# HYUNDAI Technical Service Bulletin

GROUP <b>Campaign</b>	NUMBER <b>21-01-001H</b>
DATE <b>January, 2021</b>	MODEL(S) <b>Palisade (LX2)</b>

**SUBJECT:** SIDE VIEW MIRROR HOLE PAD ATTACHMENT  
(SERVICE CAMPAIGN T50)

**Description:** This bulletin describes the procedure to attach a foam pad to the side view mirror wiring harness on certain Palisade vehicles exhibiting wind and/or whistling noise while driving.

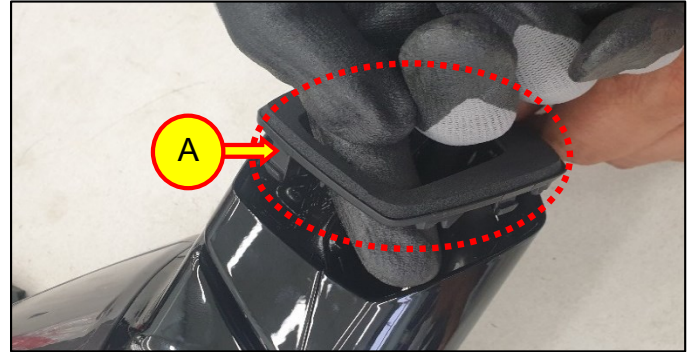
3. Remove the side view mirror seal (A).

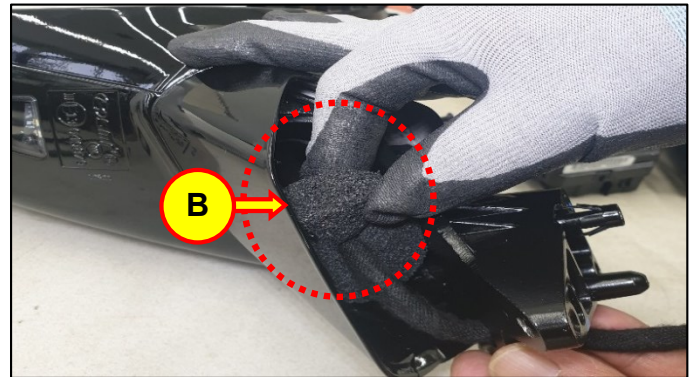
4. Place the foam pad (B) around the wiring harness.

5. Insert the foam pad through the wiring harness hole (C).
